Lower Red Basin Retention (LRBR) Study

Appendix A: HEC-HMS Model Development
Aux Marias Tributary; MB, Canada

**Red River of the North Basin-Wide Modeling Approach
Hydrologic Modeling – HEC-HMS Model Development
Various Tributaries below the Red River of the North at Halstad, MN**

Final Submittal Aux Marias Tributary, MB- Canada

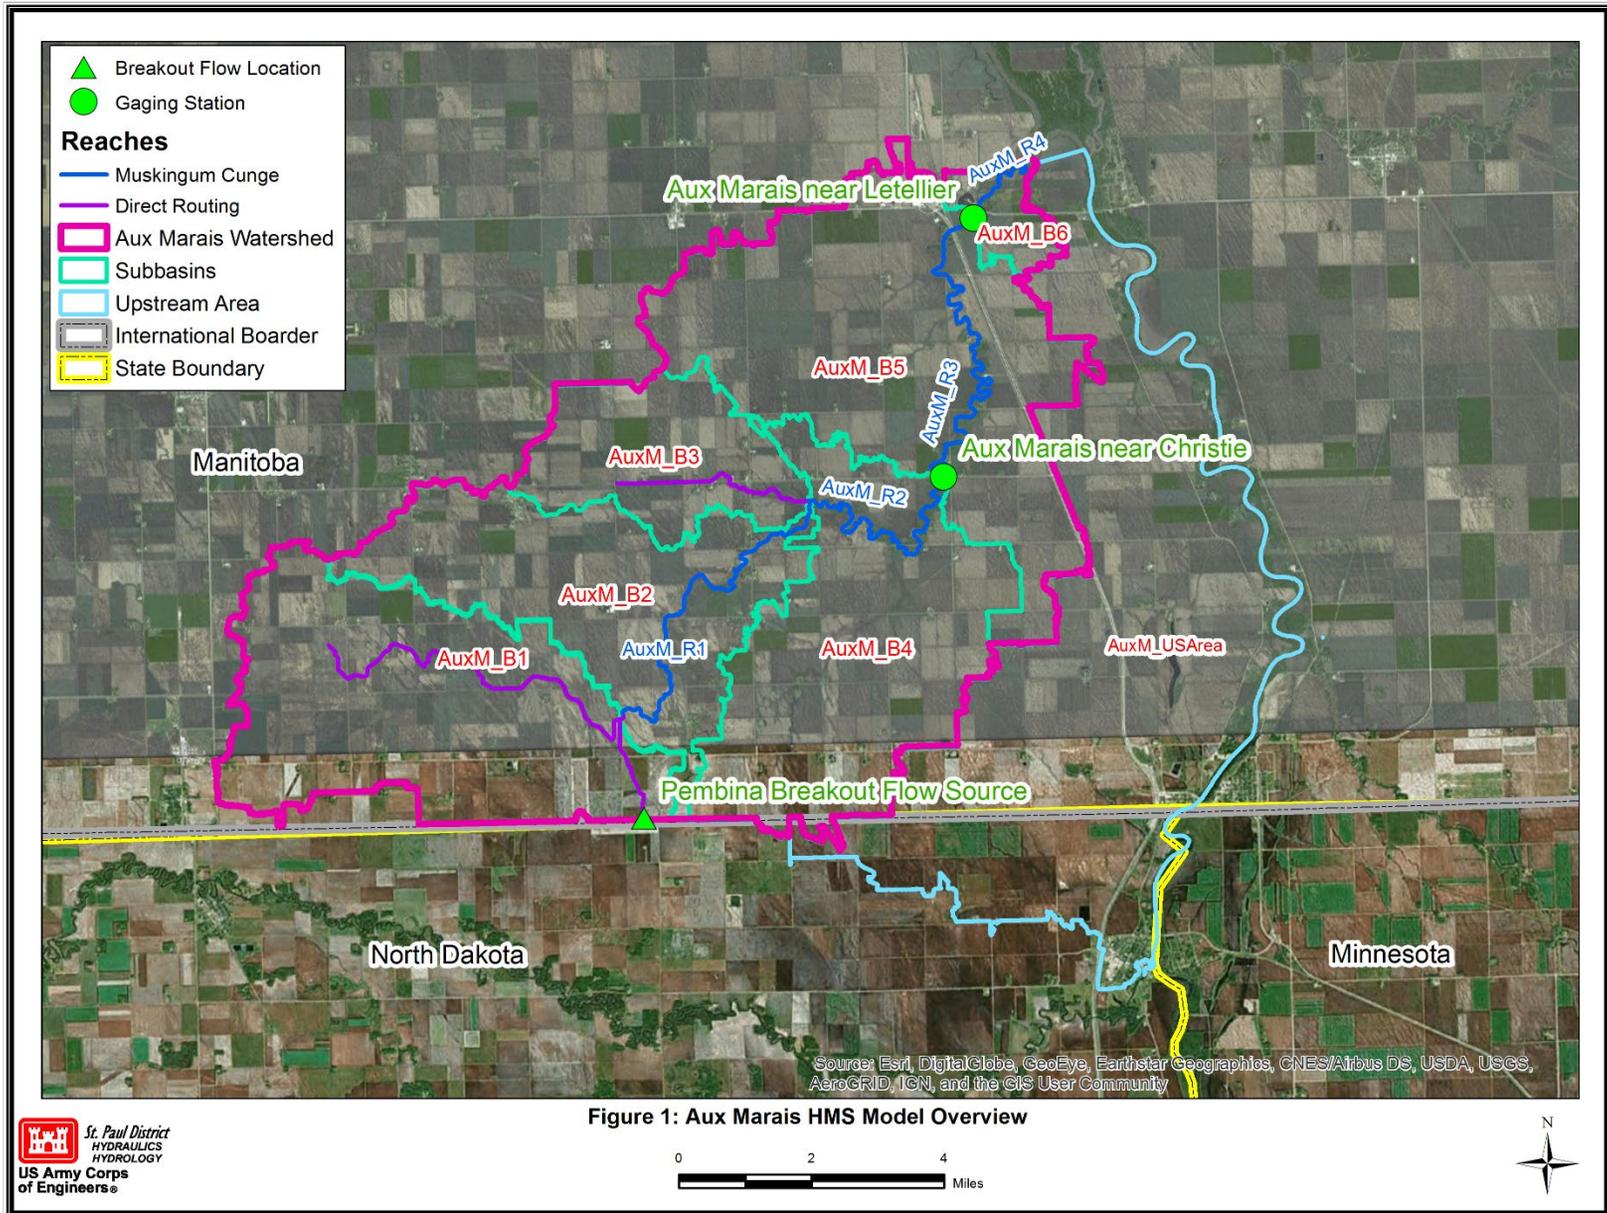
17. Only the reaches within AuxM_B3, AuxM_B1 and AuxM_B5 are Muskingum Cunge Routing reaches, the other two river delineations are for display purposes only (direct routing/none) and are incorporated in Tc – please make this clear within the figures. Consider color coding the routing reaches and adding to the legend. Please see the Pembina River 60% submittal Figure 2 as an example.

Figure 1: Subbasin Map – you have an analogous figure – but please confirm Included –Figure 1 (Aux Marais HMS Model Overview) includes the subbasin delineation.

Figure 2: Routing Methods – you have similar figures, but you need to color code the routing methods adopted completed-Figure 1 (Aux Marais HMS Model Overview) indicates where a routing method was applied (Muskingum Cunge)

Backcheck Response 1: CLOSED. The difference between reaches modeled using direct routing and Muskingum Cunge routing is now indicated by line color and clarified within the figure legend.

Figure 3 Border crossing culverts between the Aux Marais and Pembina watersheds

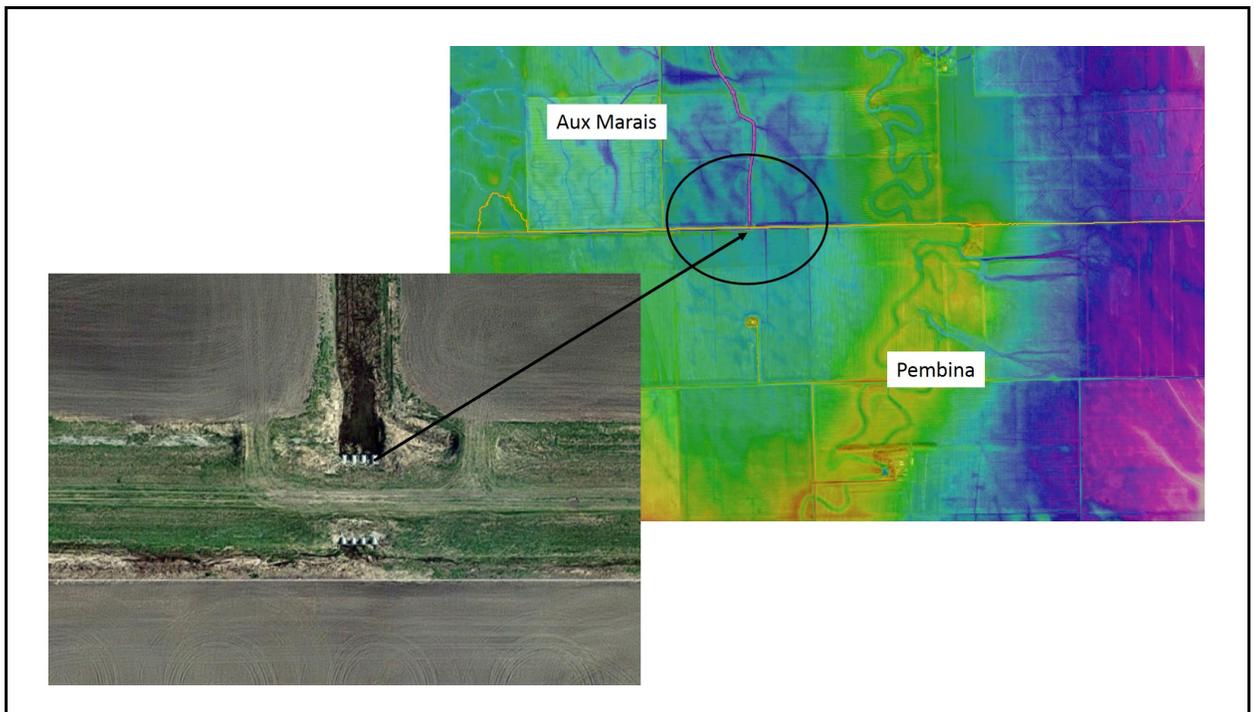
- c. More information should be added related to the location of the culverts in question. The Neche and Walhalla gage locations should be added to Figure 3.

Figure 6: 2002 calibration event results at Christie gaging station

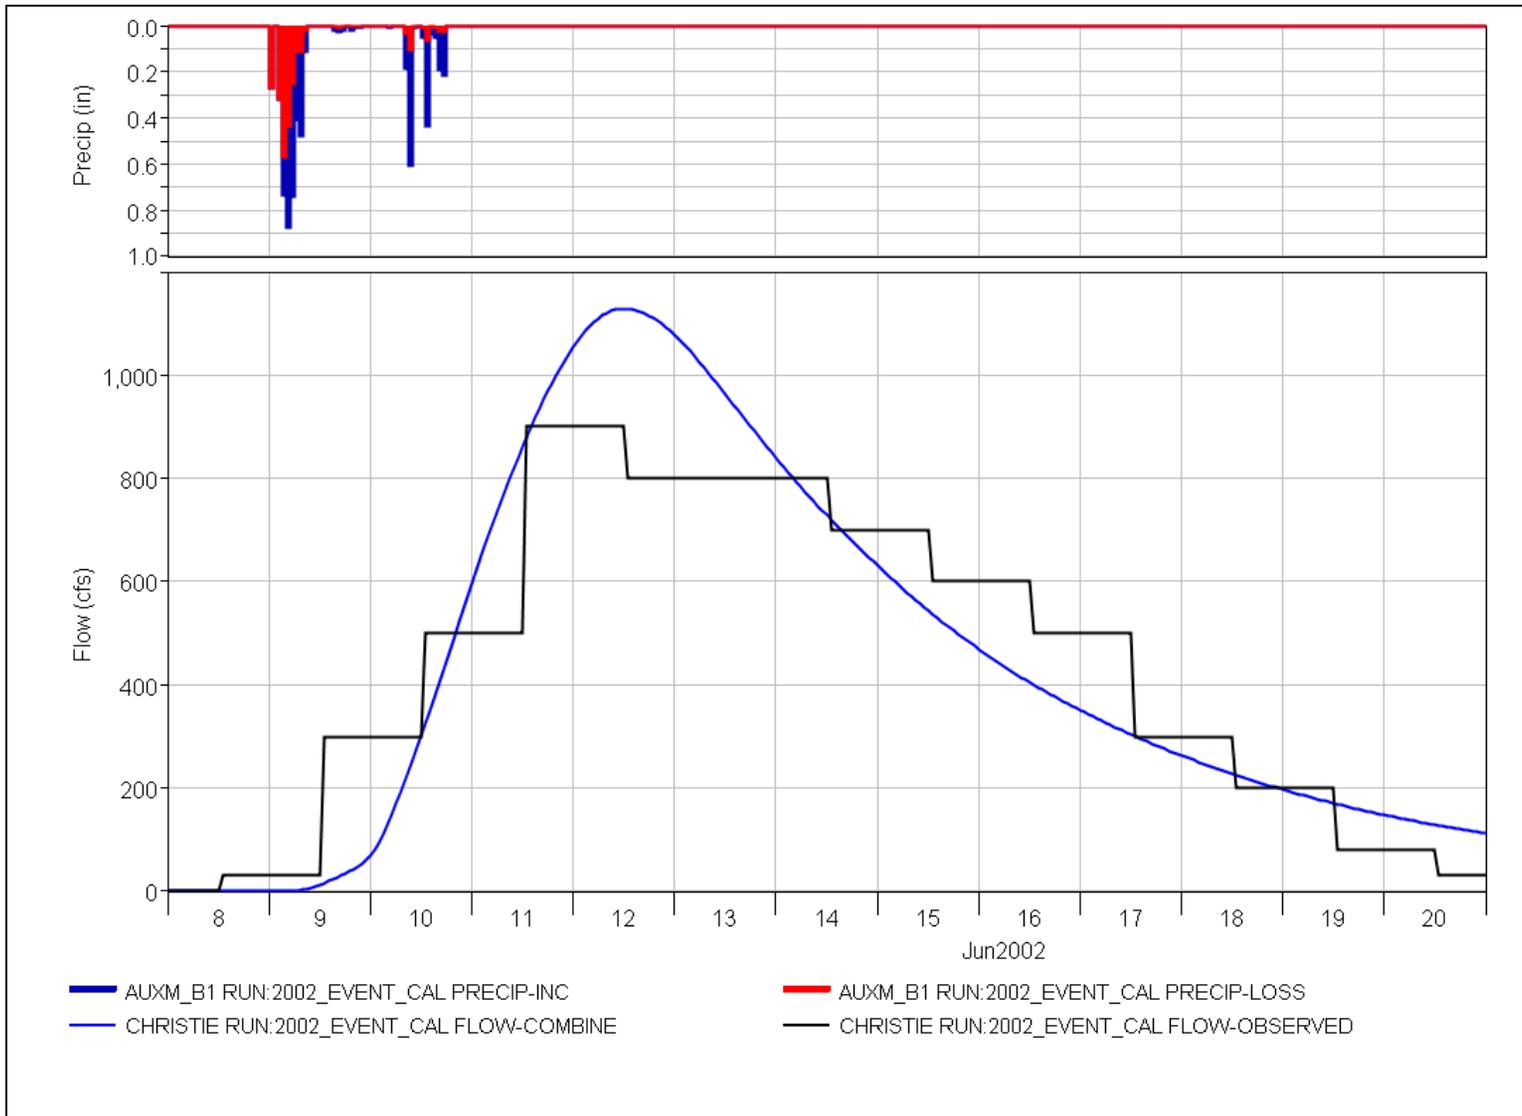
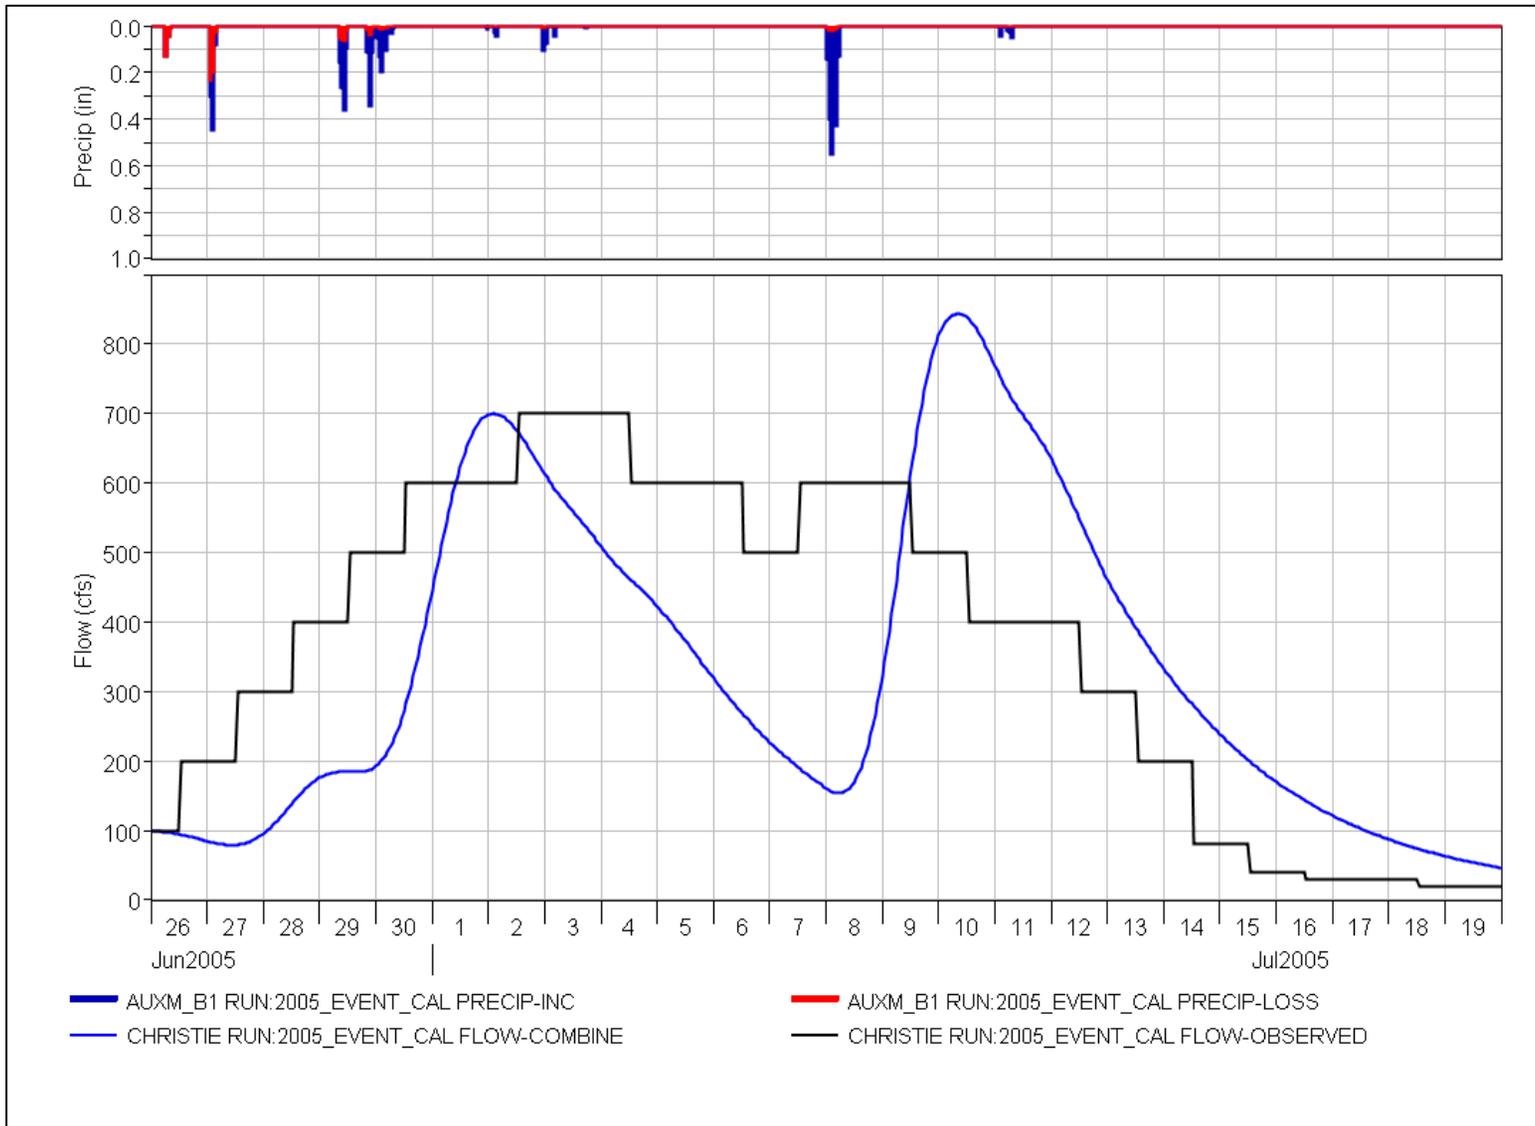
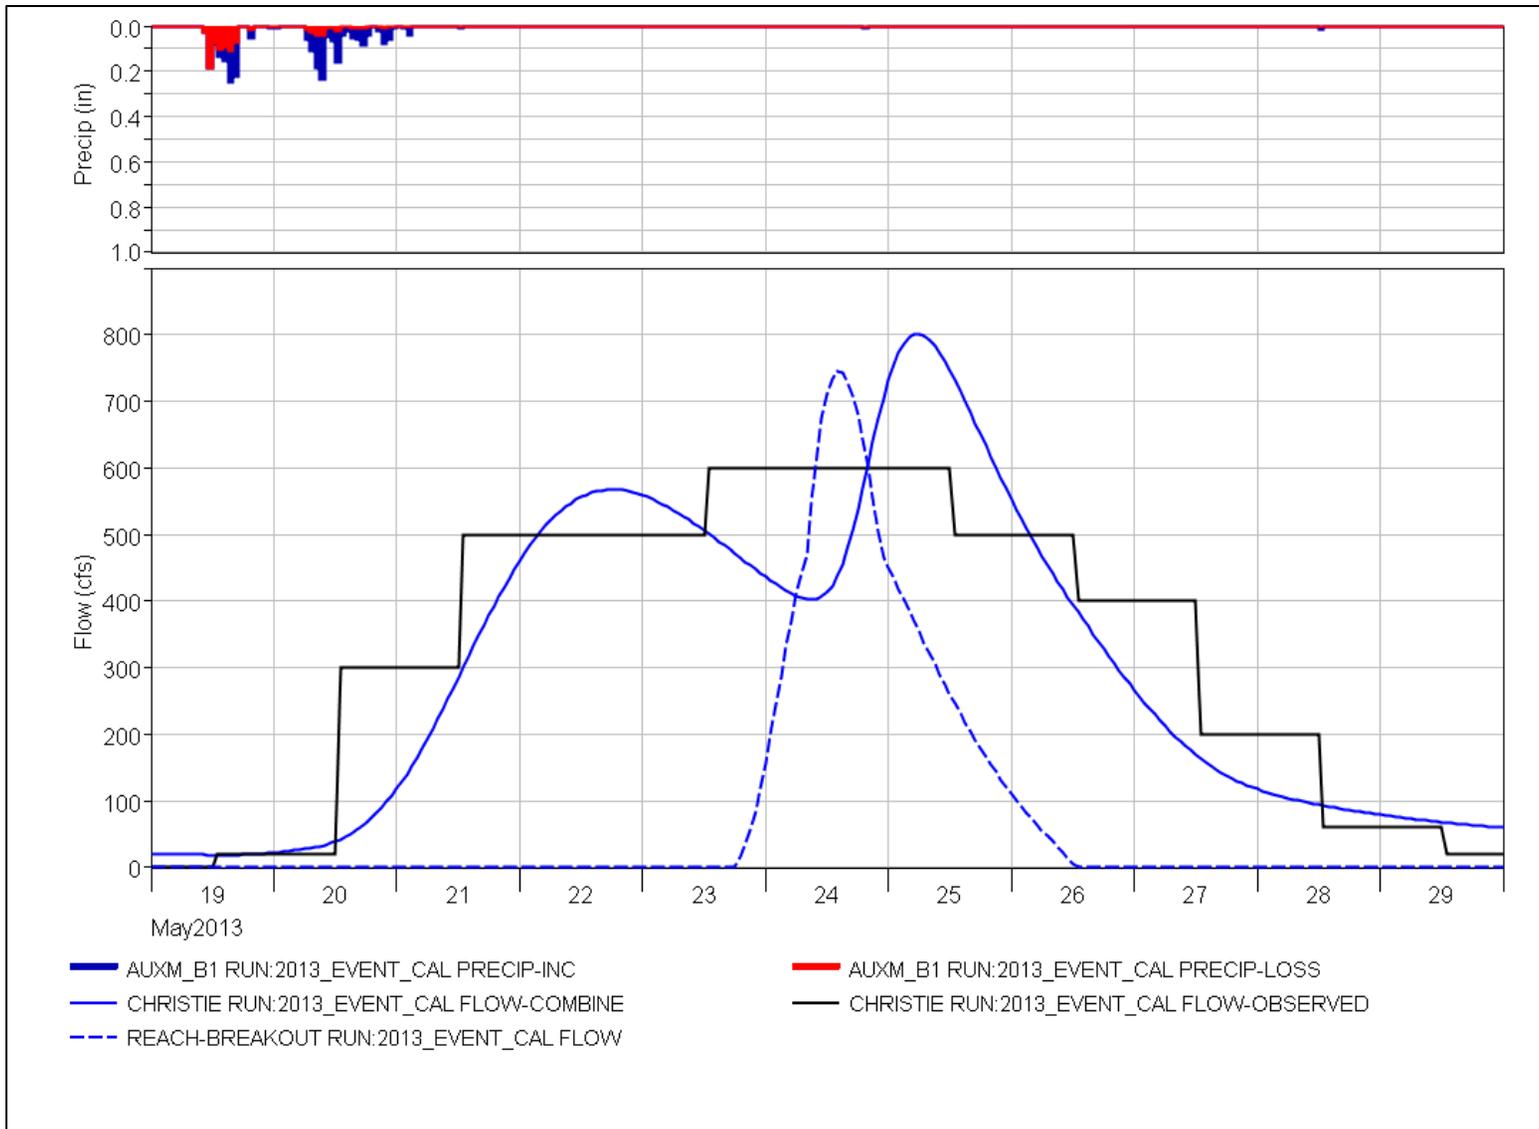
Backcheck Response 1: The calibration runs look reasonable. Please add explanation related to how you are matching observed flows in terms of timing. Consider adding a column to Table 8.

Figure 7: Precipitation for each calibration event (three figures total) - this figure is missing Precipitation is included in the calibration figures. –Displaying the precipitation associated with each calibration event on the same figure as the calibrated streamflow response is adequate.

Figure 8: Calibration Events Results- you have analogous figures

Add discussion to last paragraph in section E about timing.

Backcheck Response 2: CLOSED. A discussion of how the timing compared between modeled and observed streamflow data has been added to the write-up.
